Date: TAC Meeting - October 16, 2017

Re: Project "The Residences on Monroe Condominium"

File Number: 17-DP-52

Subject: Site Plan Review for a 40-unit residential development.

C102

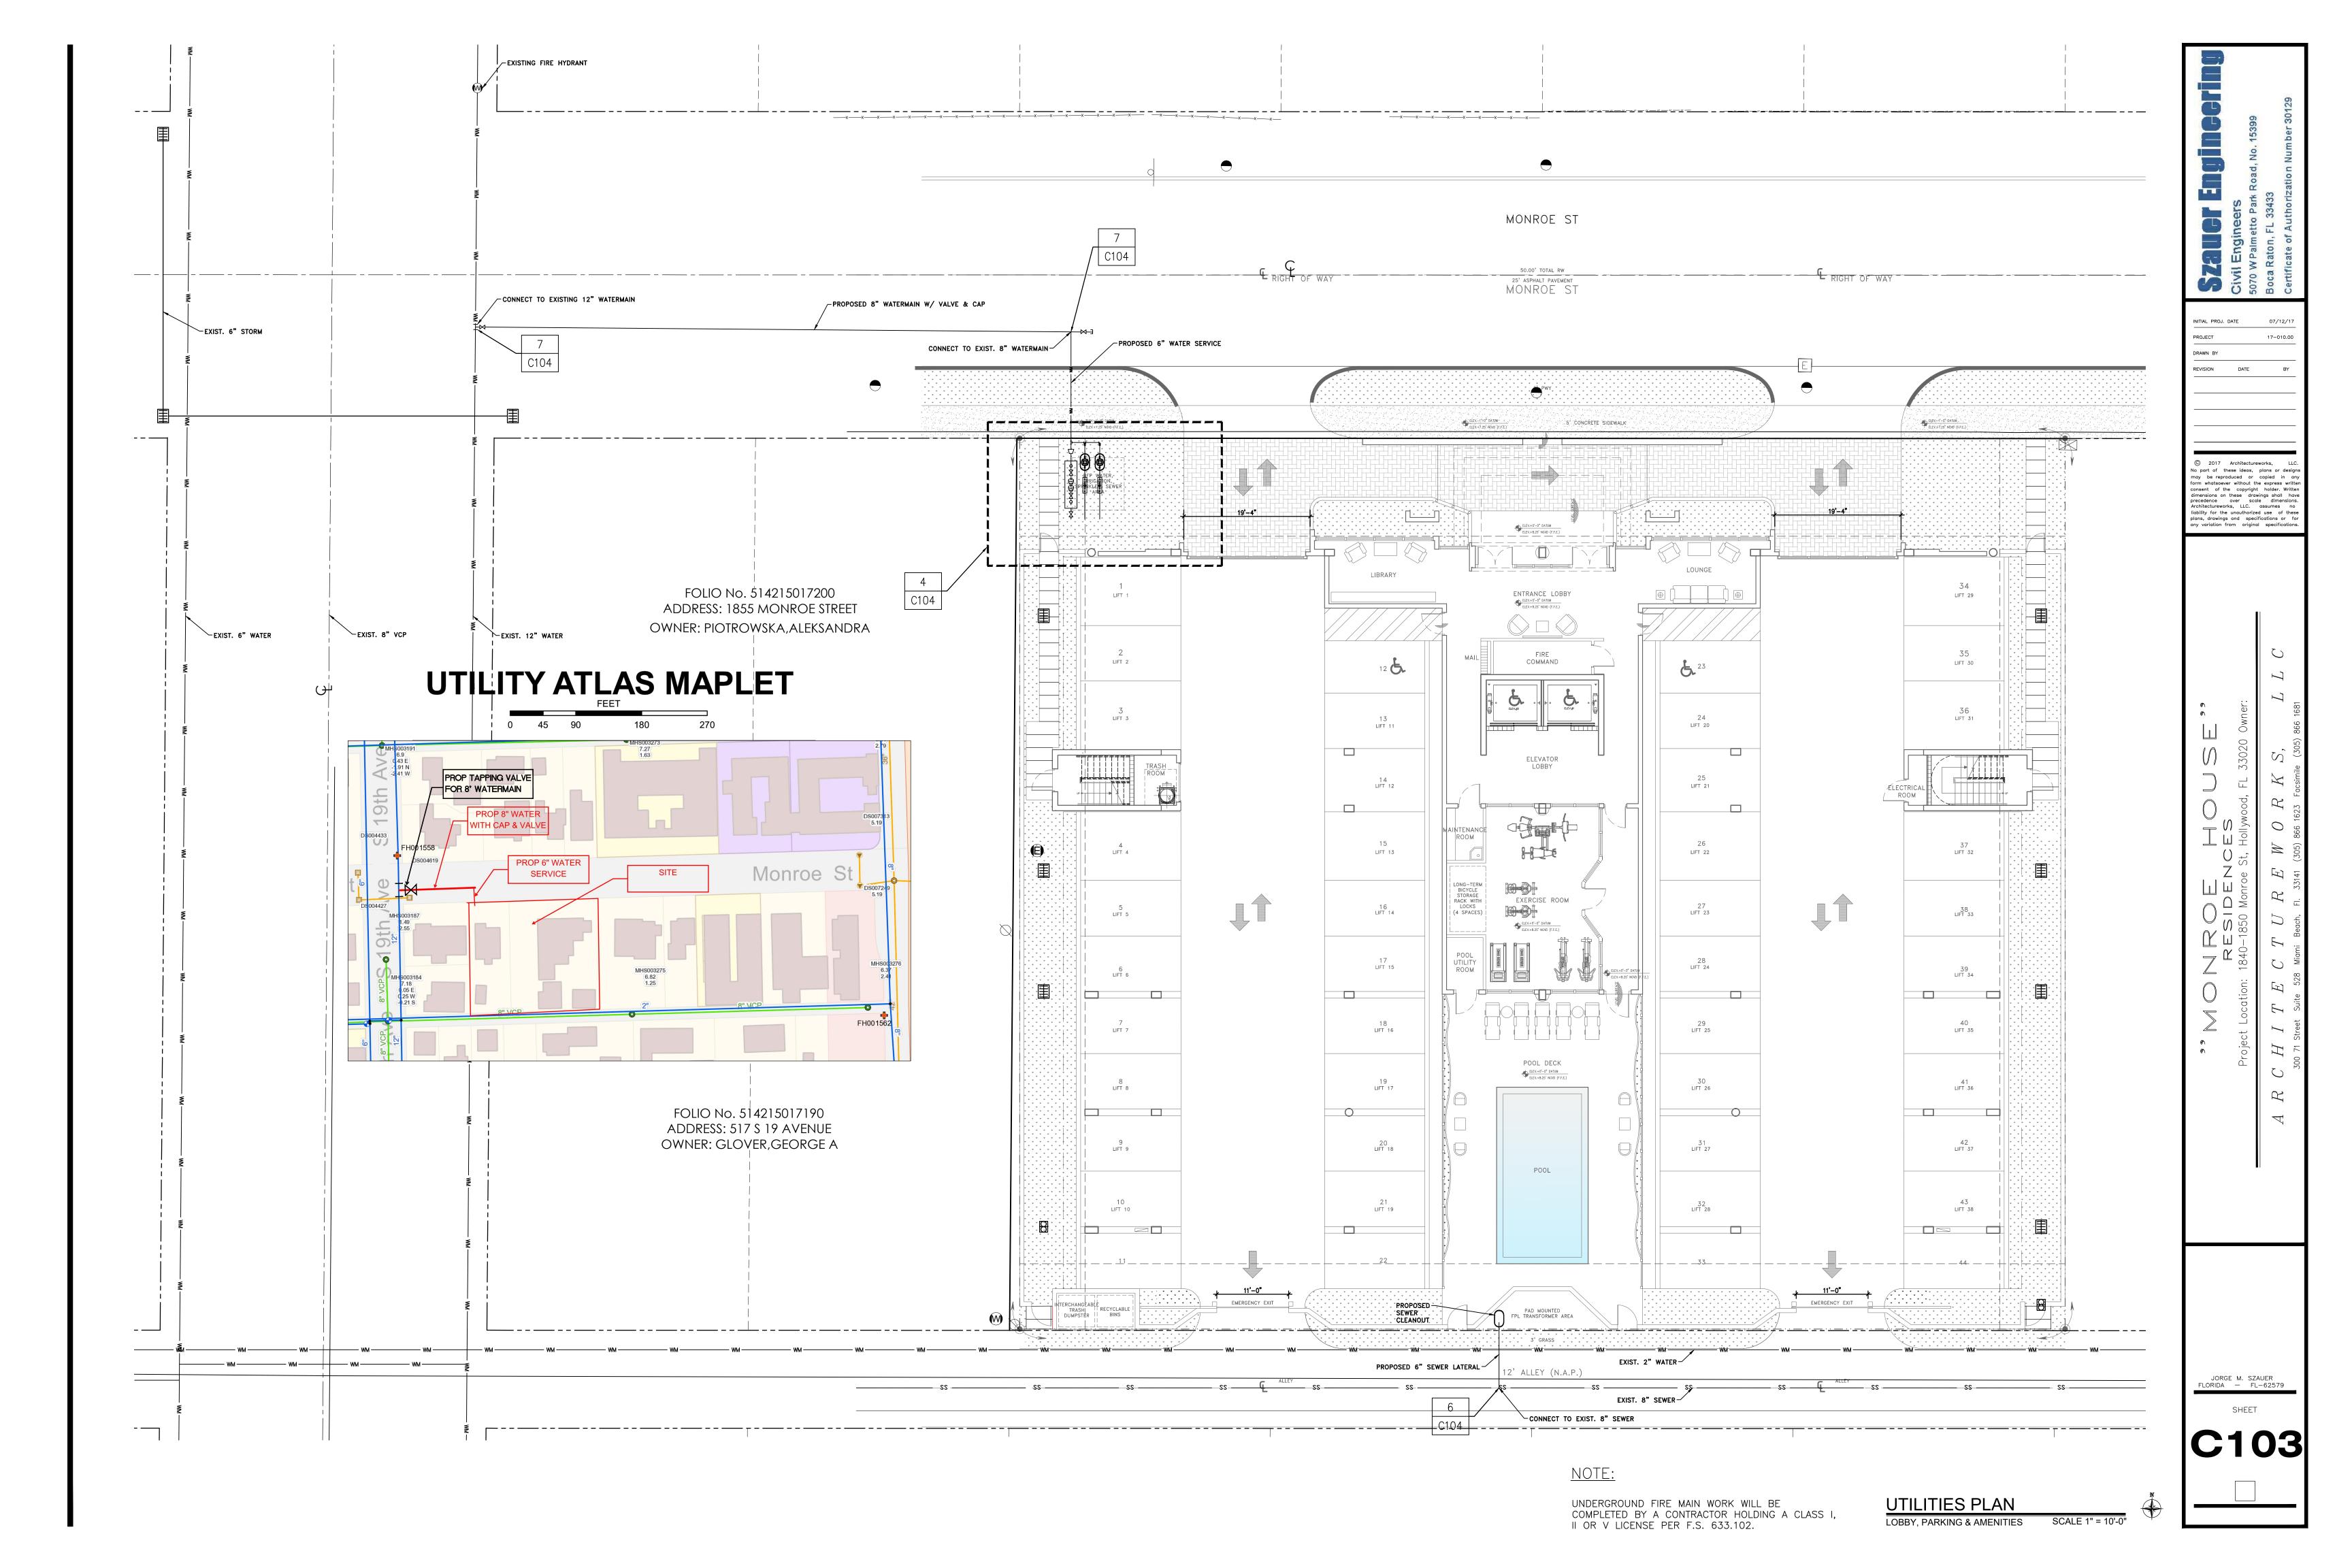
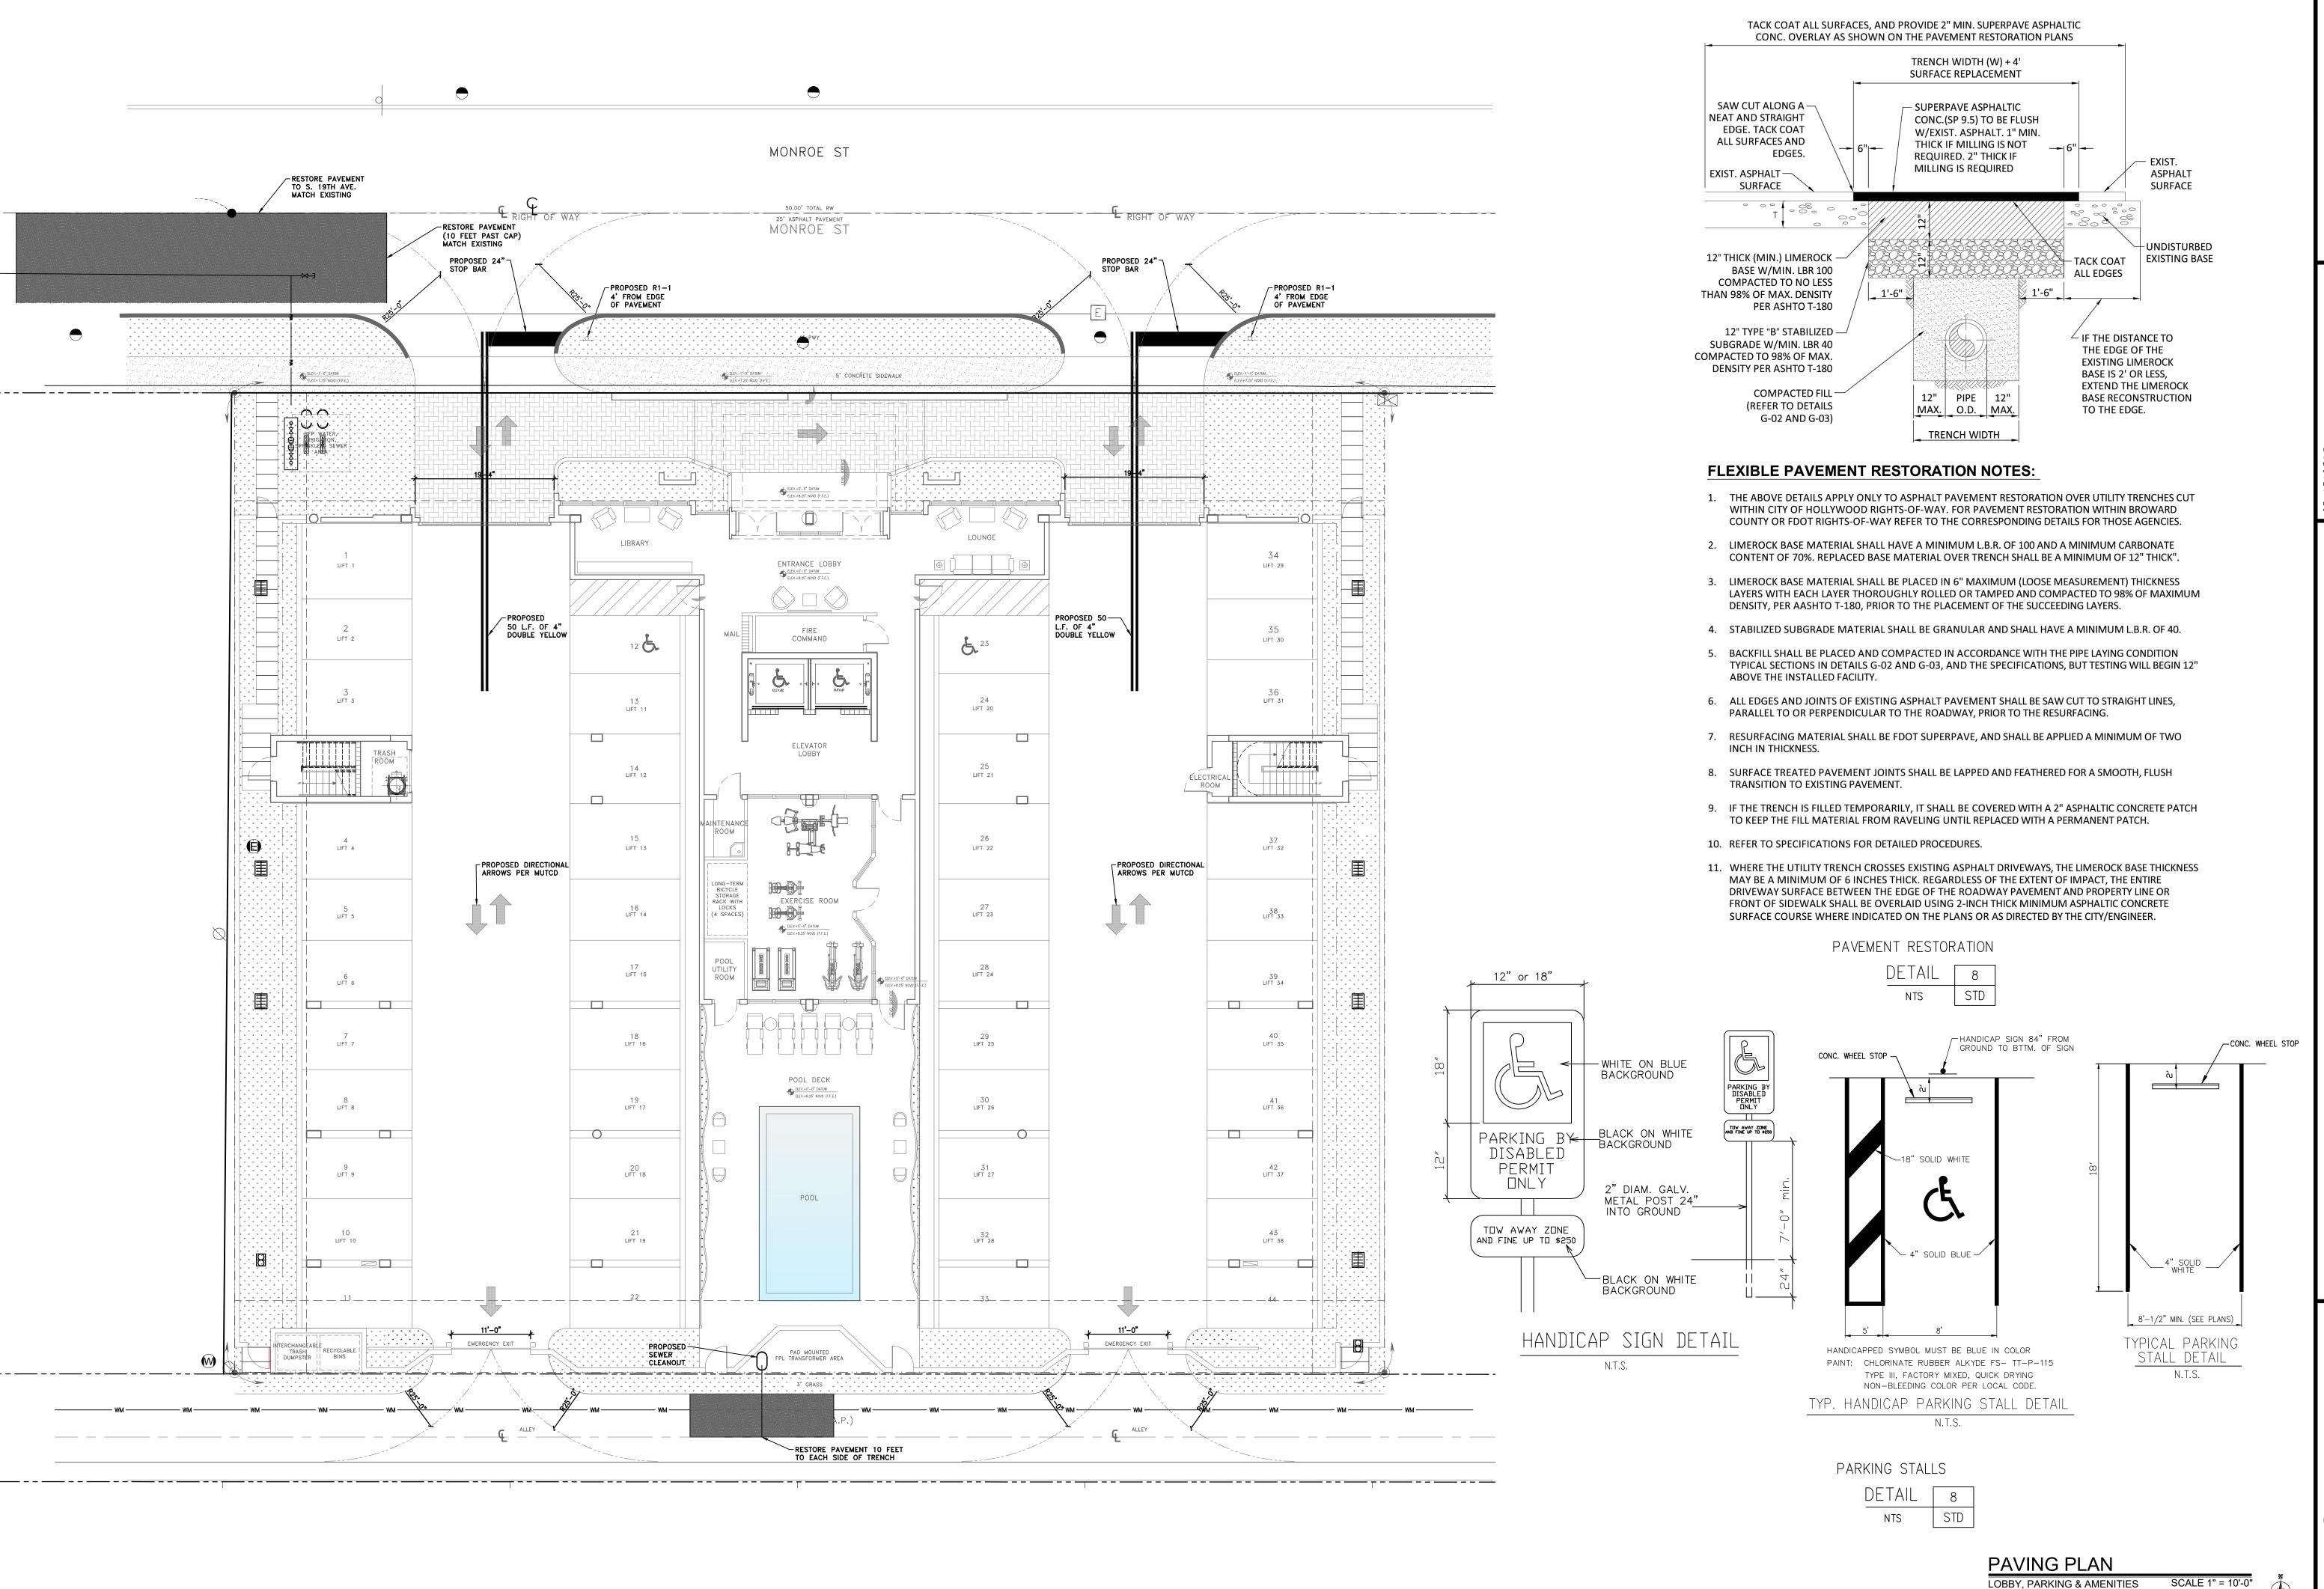
3	Provide typical cross-sections across all property lines. Plans must clearly callout a 6" deep perimeter swale, which is to be reflected in the proposed cross-sections.	Typical cross section is included in Sheet C-102
4	Verify that the proposed finished floor elevation is per section 154.50 of the City's Code of Ordinances. Please note that the bottom elevation of all machinery and electrical services serving the building must comply with the minimum finished floor elevation requirement.	Finish Floor Elevation complies with Section 154.50 of the City's Code of Ordinances. Finish Floor Elevation is above the 100-year, 3-day peak stage resulting from site specific flood routing calculations.
5	NPDES – Over 1 acre The construction activity on this site is regulated and required to obtain the NPDES Construction Generic Permit (CGP) from DEP. Failure to obtain permit coverage and/or maintain job site erosion and sedimentation control in accordance with permit conditions and applicable regulations may result in fines up to \$27,500.00 per day. Prior to issuance of building permit a Stormwater Pollution Prevention Plan (SWPPP) shall be required and CGP Notice of Intent (NOI) must be submitted to DEP. SWPPP must be maintained at the job site at all times until the project is terminated and Notice of Termination (NOT) filed with DEP. The SWPPP shall contain detailed descriptions of structures, procedures, contact names and/or control measures designed to reduce sediment and stormwater runoff. Construction sites and operations shall be required to maintain during and after all construction, development, excavation, dewatering, and/or alteration operations, structural and non-structural Best Management Practices (BMP's) with the intent to reduce pollutants and sediment in stormwater runoff. For additional information regarding NPDES regulations please contact: Florida Department of Environmental Protection 2600 Blair Stone Road, MS #2500 Tallahassee, FL 32399-2400 (850) 245-7522 Visit DEP's Web site at: www.dep.state.fl.us/water/stormwater/npdes	Noted

11	On civil plans, provide cross-section at property lines, include perimeter wall footing. Be sure perimeter wall footing is within property limits.	See Sheet C-102
